Marathon Cty. Sheriff's Dept TRC & Storage Bldg. Renovations 1000 Lakeview Drive Wausau, WI 54403 Angus Young Associates Project No. 77081

ADDENDUM #01

Monday, March 04, 2024

STRUCTURAL GENERAL NOTES

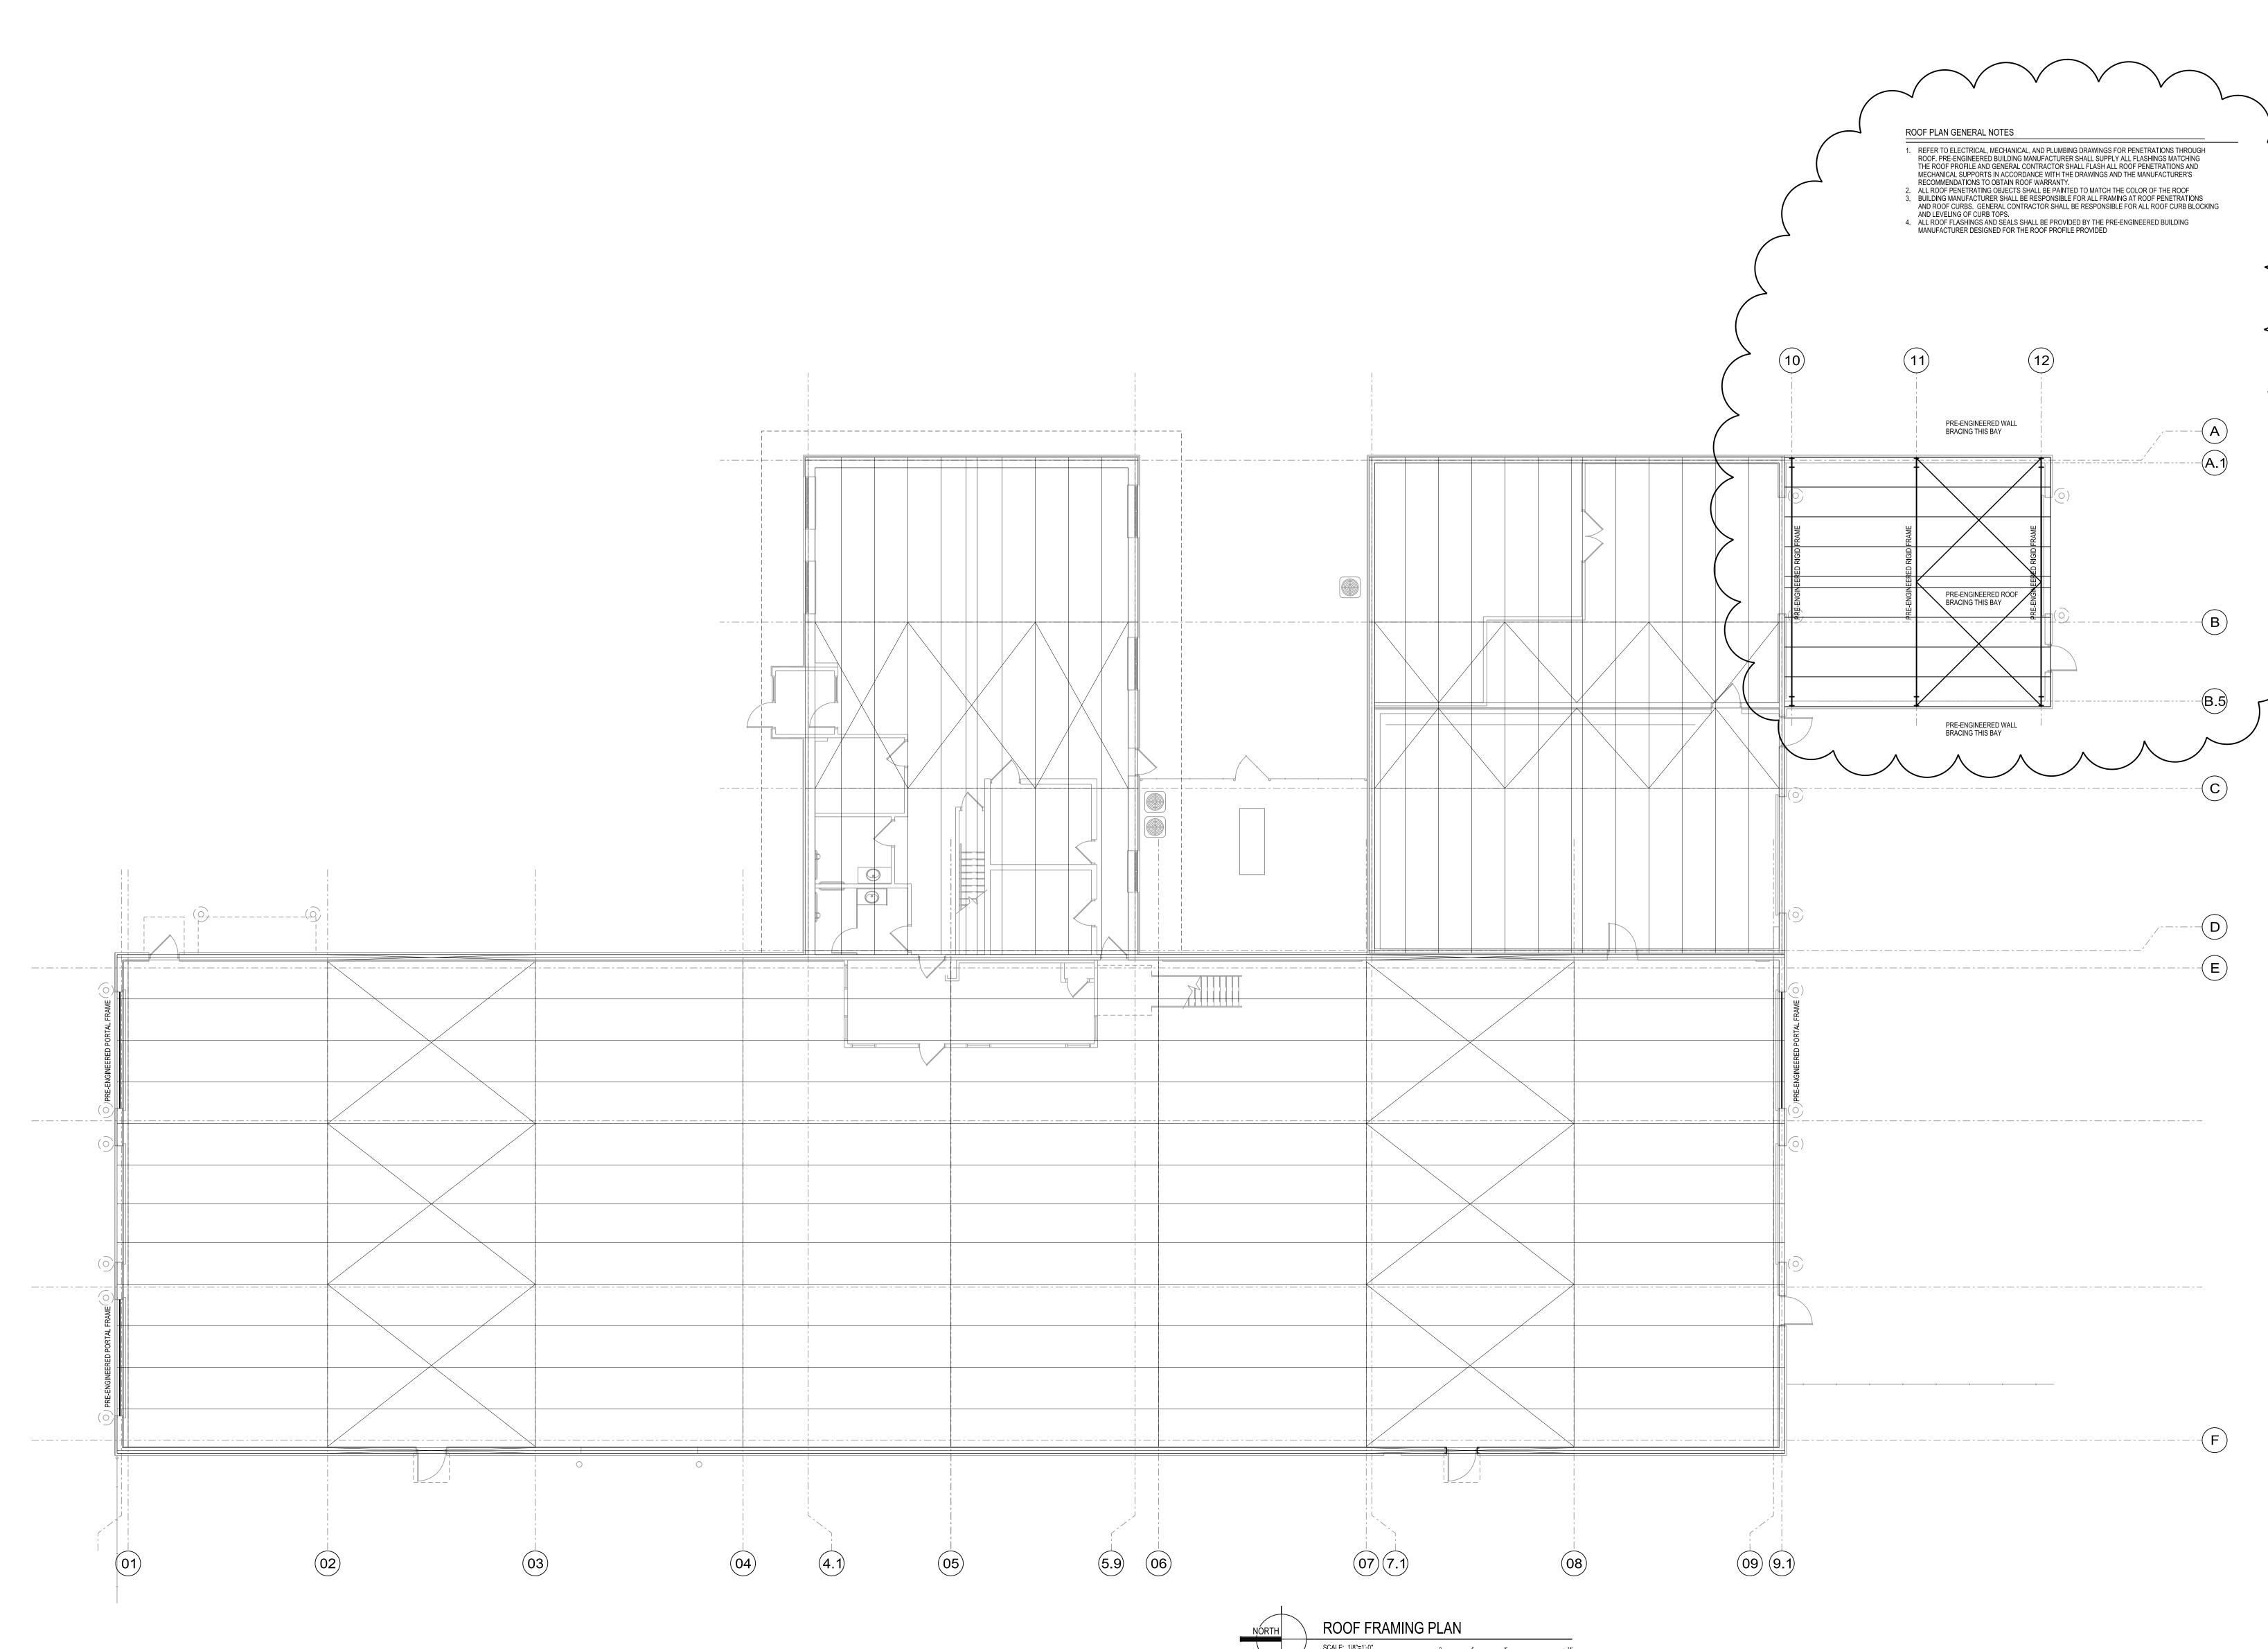
H. Sheet S301 Structural Notes:

a) Refer to added sheet.

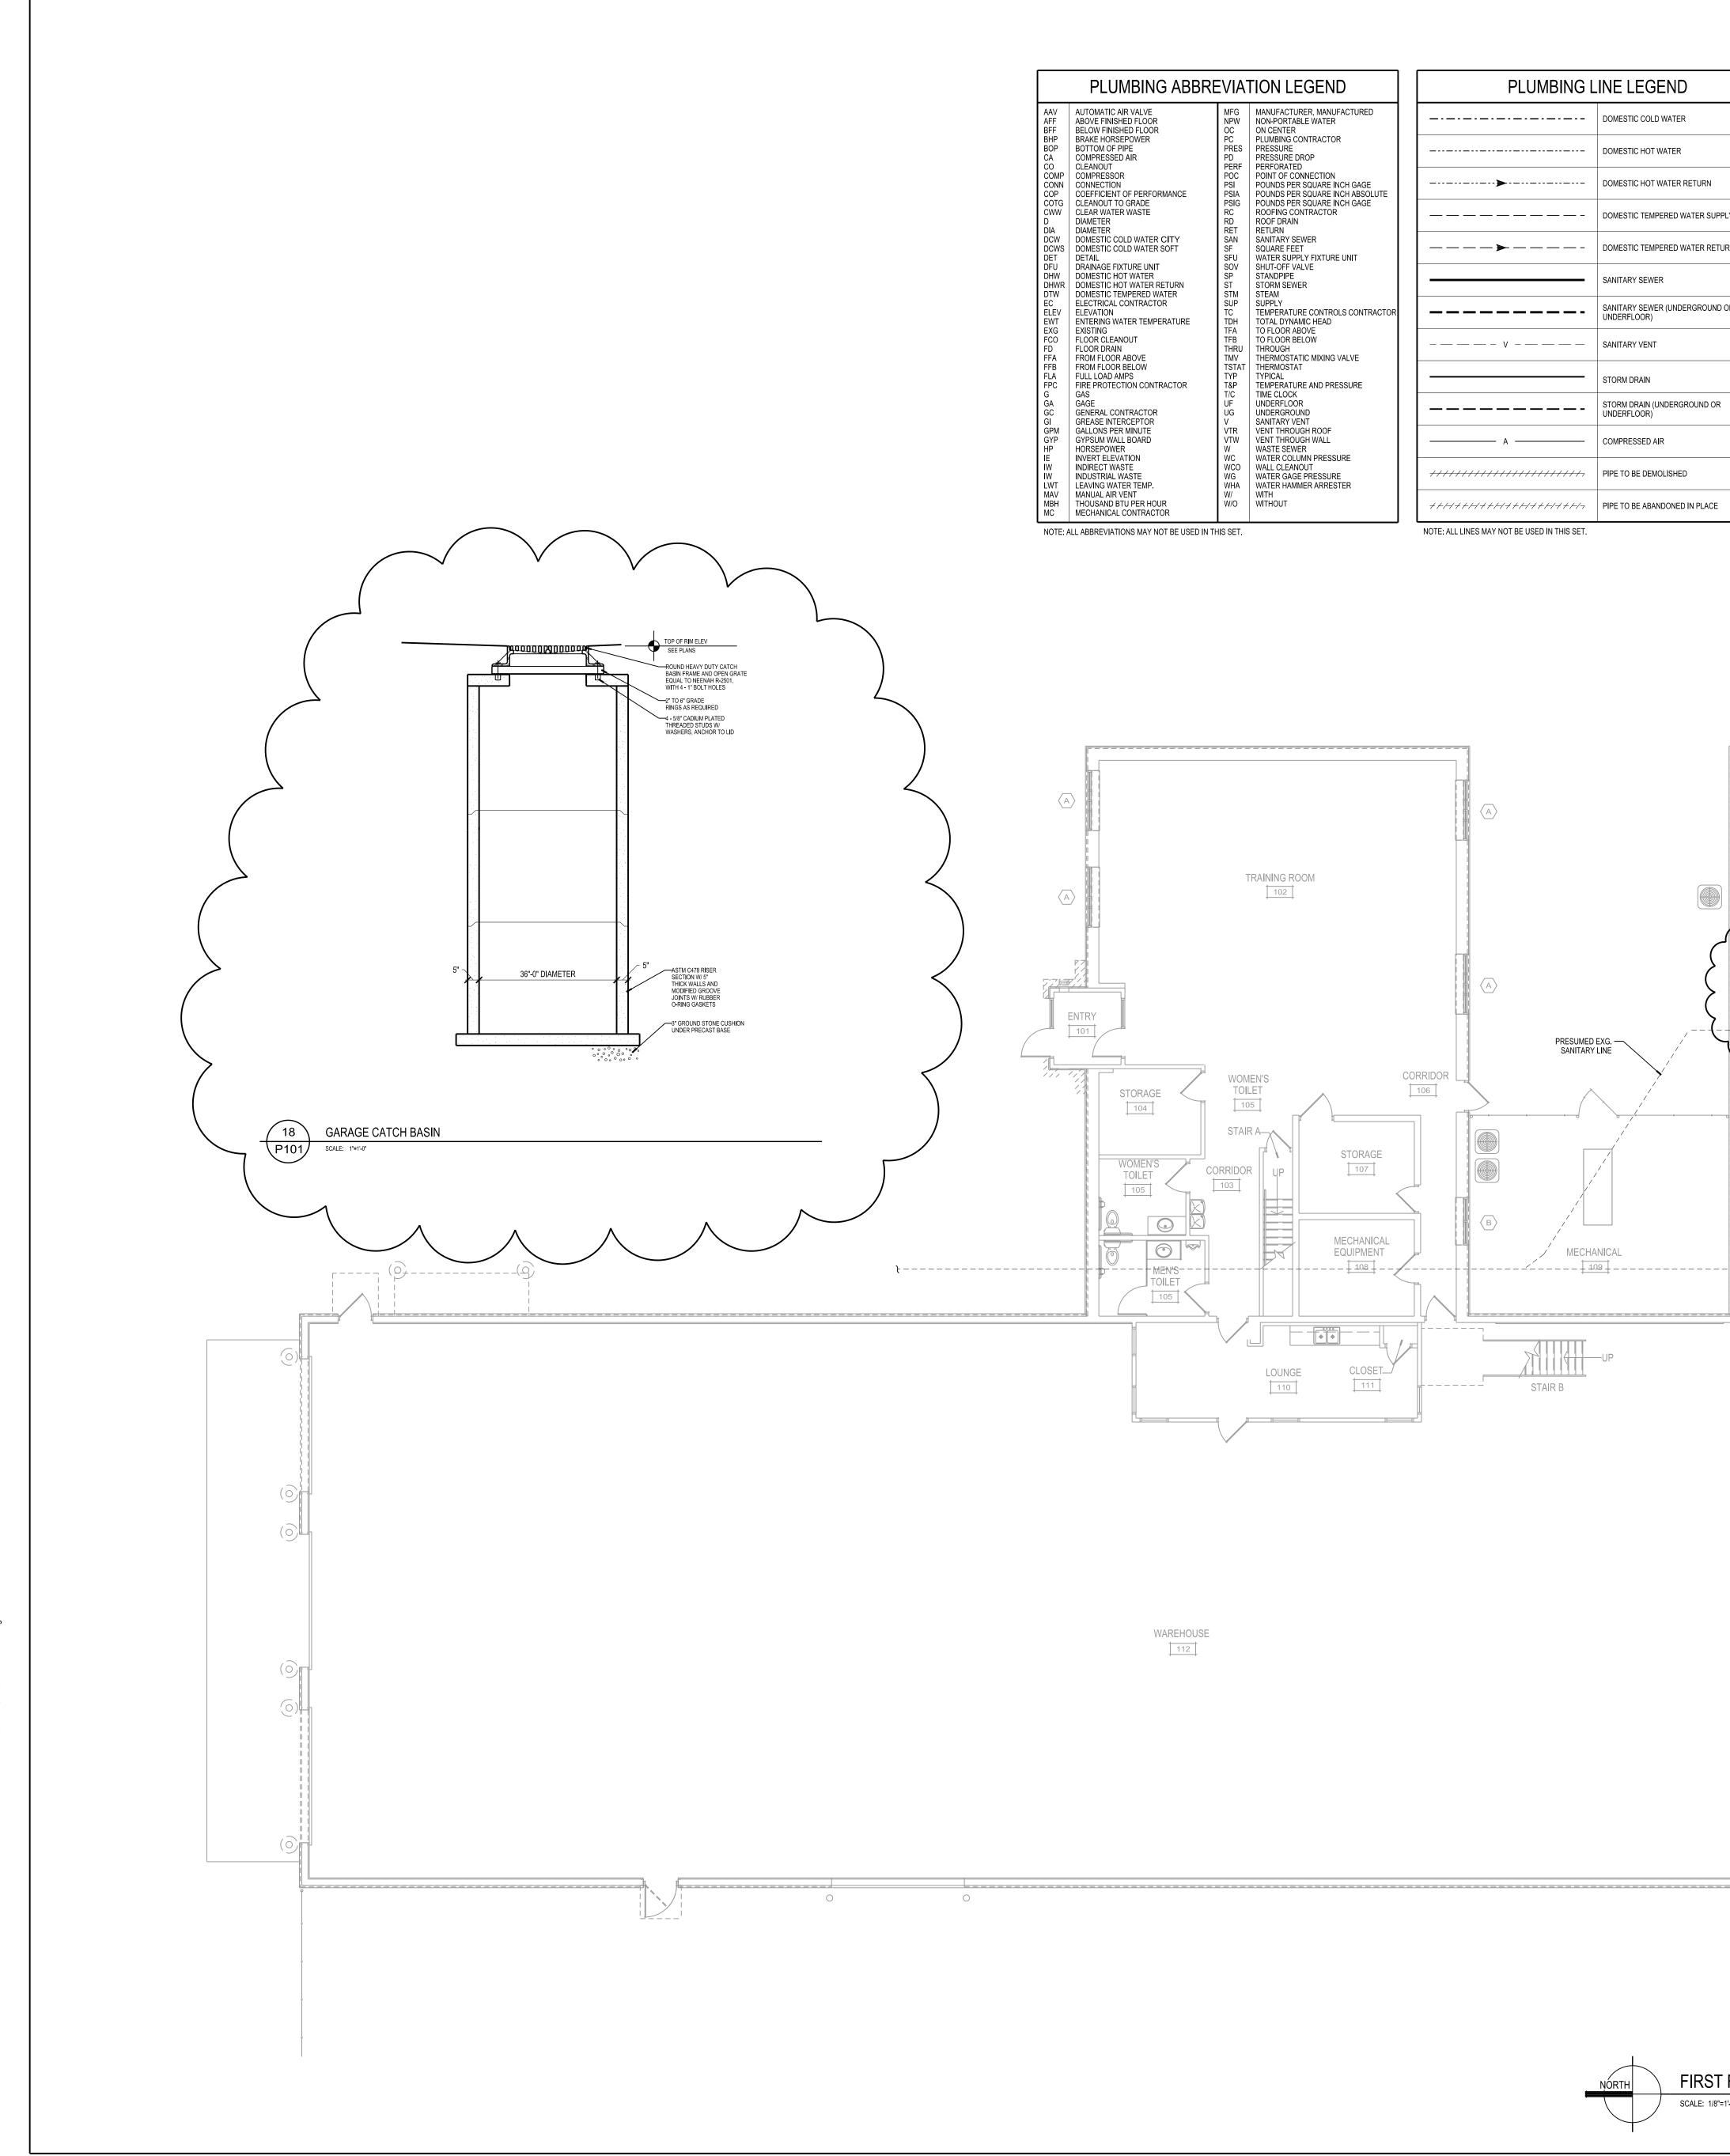
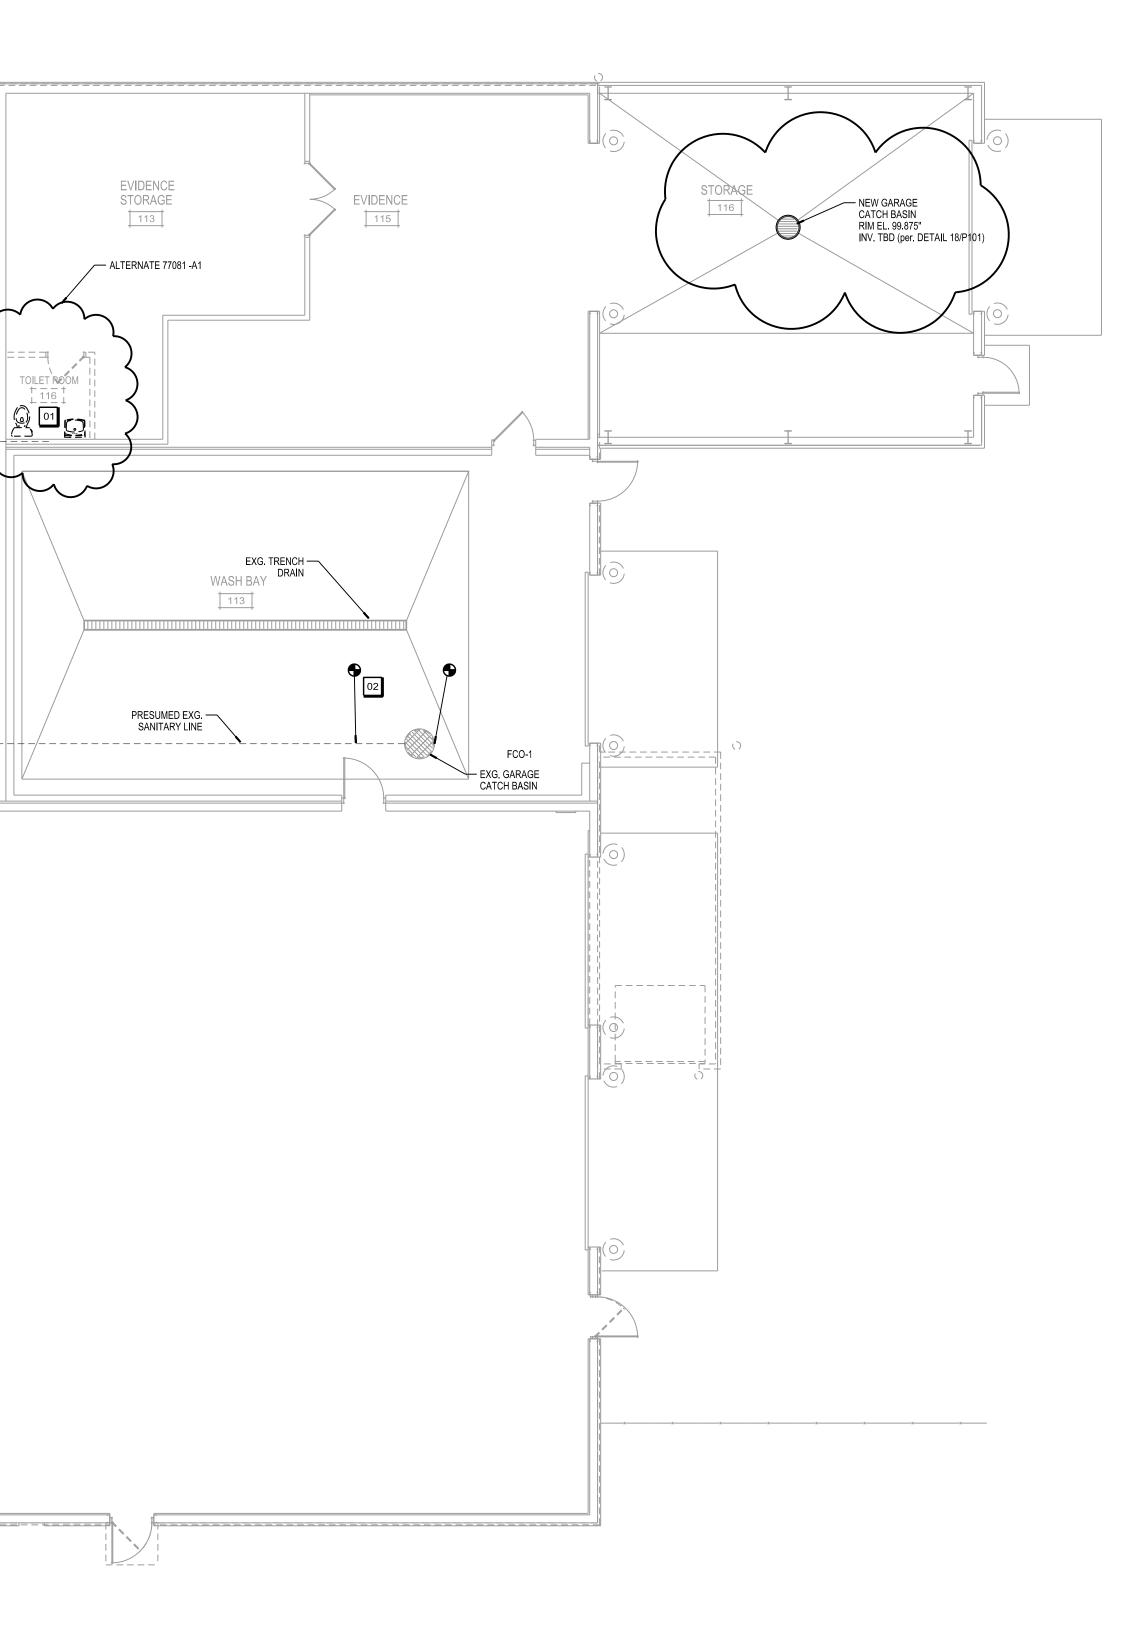
J. Sheet P101 Plumbing Plan:

a) Refer to revised plumbing plan. The new catch basin is to have no piping from it. It will be pumped out as needed based on the garage not being used for vehicle maintenance etc.
